# Special Exception Alternative Compliance 901 and 903 Cypresstree Drive

## SE-25003 AC-25002

**TECHNICAL STAFF REPORT:**

SUBJECT: Special Exception SE-25003 and Alternative Compliance AC-25002  
901 and 903 Cypressstree Drive

# ELEVATIONS

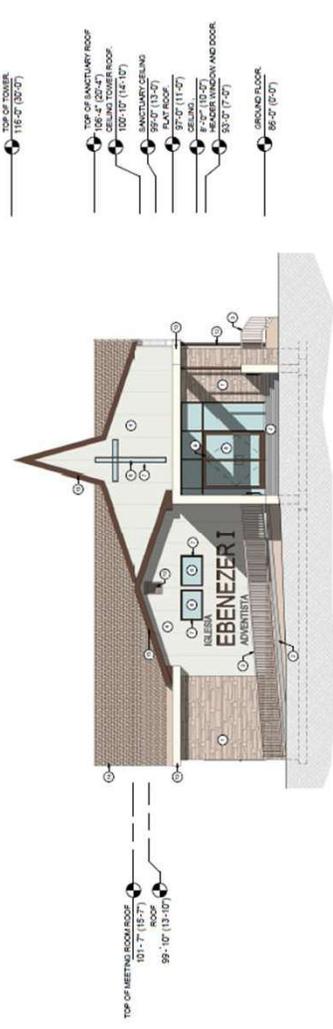
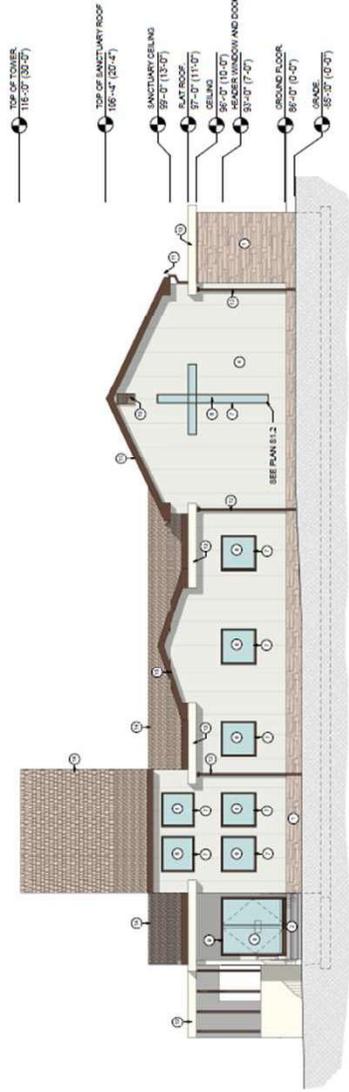
MATERIAL LEGEND:	
①	SLATE PANEL / VENEER WALL - LIGHT BROWN (R/S 25-204-189)
②	CONCRETE STAIR AND PAMP - GRAY (R/S 18-182-182)
③	PAVING - DARK BROWN (R/S 10007-060)
④	WIDE PLANK SONG - ALUMINUM (R/S 237-237-231)
⑤	TRIPLE DOOR - DARK BROWN (R/S 19-100-1)
⑥	WINDOWS (GLASS) - LIGHT BLUE (R/S 19-232-232)
⑦	WINDOWS (FRAME) - DARK BROWN (R/S 10007-060)
⑧	STOREFRONT (GLASS) - LIGHT BLUE (R/S 19-232-232)
⑨	STOREFRONT (FRAME) - DARK BROWN (R/S 10007-060)
⑩	LOWER - DARK BROWN (R/S 10007-060)
⑪	ALUMINUM CLUTTER - DARK BROWN (R/S 10007-060)
⑫	DOWNPOUT - DARK BROWN (R/S 10007-060)
⑬	FRONT PLANT ROOM - HORTY COLOR (R/S 24-242-239)
⑭	IMPACT SHIELDS ROOF - LIGHT BROWN (R/S 235-234-189)
⑮	ROOF EDGE - DARK BROWN (R/S 10007-060)

REMARK REVISION DATE  
ISSUED: 02/02/23 3:25:54 PM  
SCALE AS NOTED  
DRAWN BY: L/N CHECKED BY: J.C.  
PROJECT NO. 24-1008 JC  
SIGNAGE PLAN  
SHEET: **A8.0.**

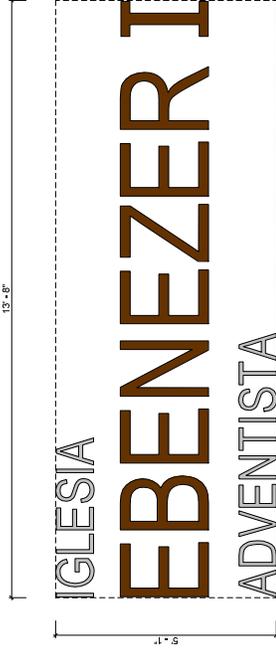
1. The dimensions of the final building footprint need to be added to Sheet C200 of the special exception plan.
2. The method of erecting the channel letters of the building sign should be added to the signage sheet.
3. The Permit Review Section offers no further comments at this time on this development application with Alternative Compliance AC-25002.
